SUNDRY NOTICES AND REPORTS ON WELLS

8. Well Name and No.
INDIAN BASIN C GAS FEDERAL COM 2

OXY USA WTP LP respectfully requests to temporarily abandon this well. It is currently being evaluated for possible Yeso recompleation.

Temporary Abandonment of Wells on Federal Lands
Conditions of Approval

OXY USA WTP LP
Indian Basin C Gas Federal Com #2
API No. 30-015-31396

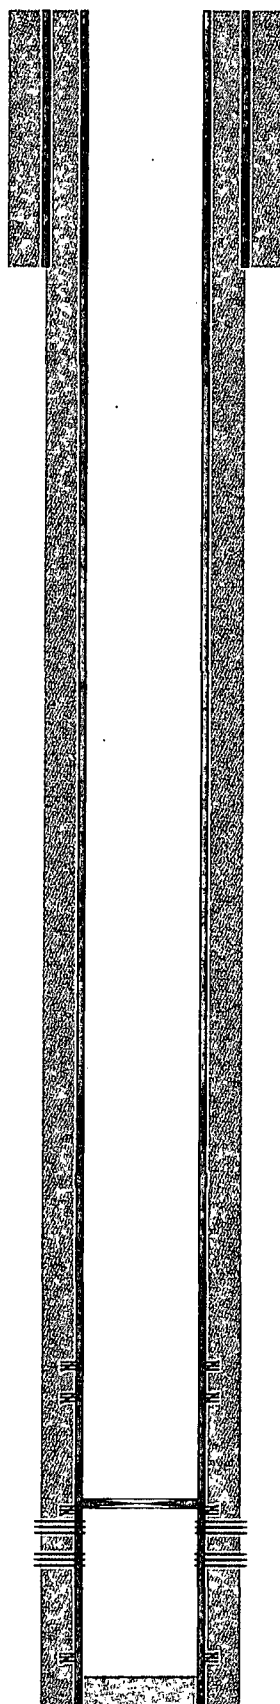
1. RIH & set CIBP @ +/- 6948' 6300'
2. Notify BLM/NMOCD of casing integrity test 24hrs in advance.
3. RU pump truck, circulate well with treated water, pressure test casing to 500# for 30 min.

CIBP @ 6948'

6300'
